Well Name: SUNDANCE 1 FED	Well Location: T24S / R31E / SEC 1 / NWSW /	County or Parish/State: EDDY / NM
Well Number: 8	Type of Well: OIL WELL	Allottee or Tribe Name:
Lease Number: NMNM69369	Unit or CA Name:	Unit or CA Number:
US Well Number: 3001529686	Well Status: Oil Well Shut In	Operator: OXY USA INCORPORATED

Type of Submission: Notice of Intent	Type of Action: Plug and Abandonment
Date Sundry Submitted: 11/07/2022	Time Sundry Submitted: 03:02
Date proposed operation will begin: 12/07/2022

NOI TO PLUG AND ABANDON WELLBORE 11/7/22

Proposed Wellbore
SUNDANCE 1 FEDERAL #008
30-015-29686-0000
Eddy

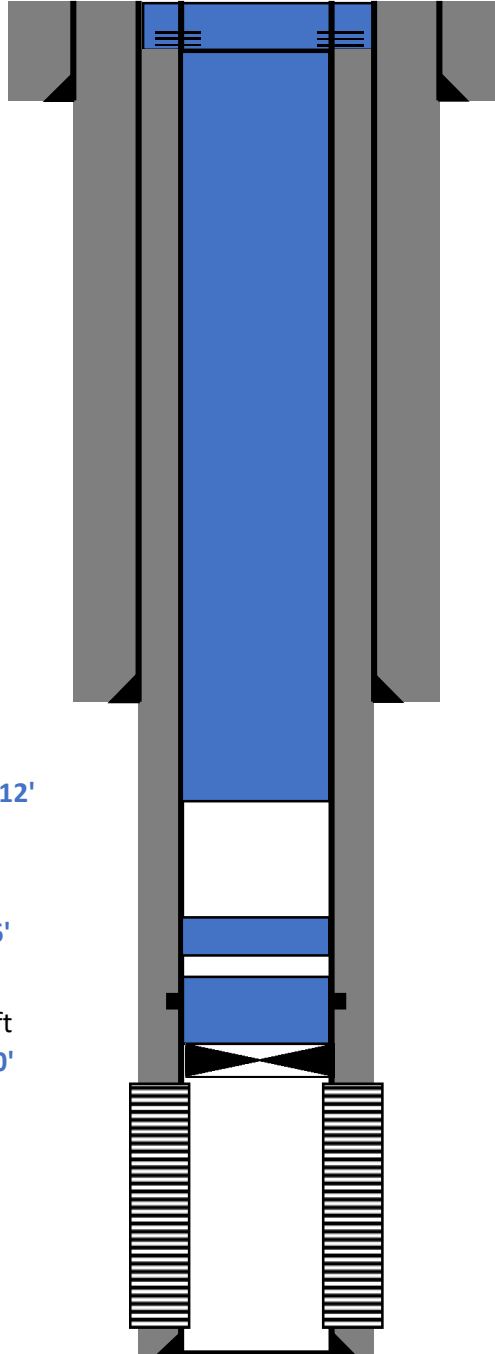
SET CIBP AT 6728'. LEAK TEST. **Leak test:**
SPOT 65 SX CMT 6728'-6166'. **500psi, 30mins**
WOC AND TAG.

Plug Type	Top	Bottom	Length	Tag	Sacks	Notes
Surface Plug	0.00	300.00	300.00	Verify circulated to surface	80.00	Potash- Salt surface plug. Perf and sqz from 300' to surface
Shoe Plug	566.77	673.00	106.23	WOC and Tag	480.00	Potash- Salt surface plug. Spot 4584' to 300'
Top of Salt @ 958	898.42	1008.00	109.58	WOC and Tag	480.00	Potash- Salt surface plug. Spot 4584' to 300'
Base of Salt @ 4282	4189.18	4332.00	142.82	WOC and Tag	480.00	Potash- Salt surface plug. Spot 4584' to 300'
Shoe Plug	4288.18	4432.00	143.82	WOC and Tag	480.00	Potash- Salt surface plug. Spot 4584' to 300'
Delaware @ 4534	4438.66	4584.00	145.34	WOC and Tag	480.00	Potash- Salt surface plug. Spot 4584' to 300'
CIBP Plug	6693.00	6728.00	35.00	WOC and Tag	65.00	Leak test 500psi, 30mins
